SUNDRY NOTICES AND REPORTS ON WELLS
*Do not use this form for proposals to drill or to re-enter an
Abandoned well. Use Form 3160-3 (APD) for such proposals.*

Elliott Gas Com A 1B

30-045-31841

☐ Other Exception to

Client : bp
Well : Surface Job (80F)
String : 15.8 ppg G + 3% S001
District :
Country : USA

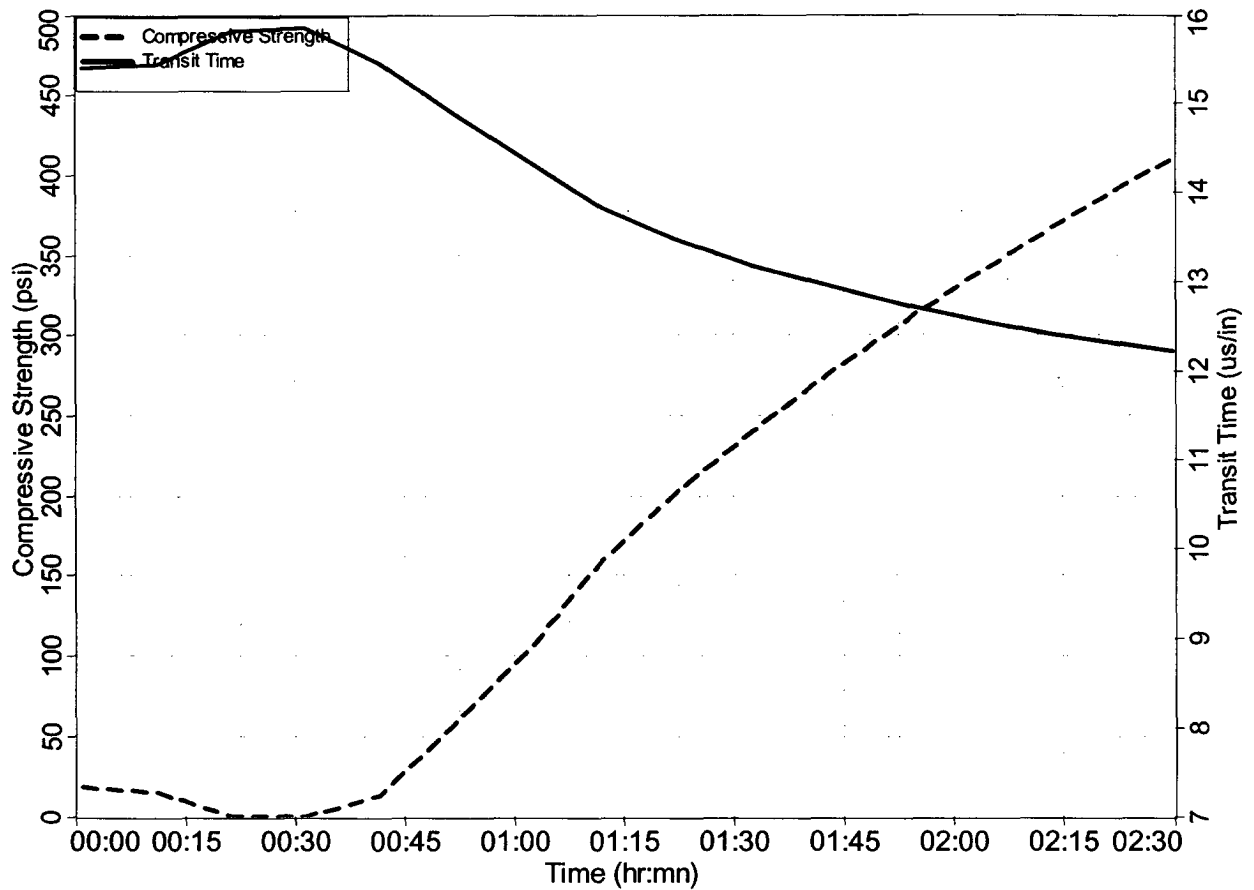
BP is currently using 3% CaCl₂ in our slurry and achieves 300 psi compressive strength after 1 hr 50 min and 500 psi after 3 hrs 8 min. We, therefore, request approval to initiate blowout preventer (BOP) nipple up operations after a 2 hour wait on cement time in lieu of the 6 hour time frame required by rule to achieve 300 psi compressive strength with Class B cement slurry at 80 deg F.

3% CaCl₂ will be used, NOT 2% as originally approved.

Comply with Rule 1076 *CP*
NMOCD
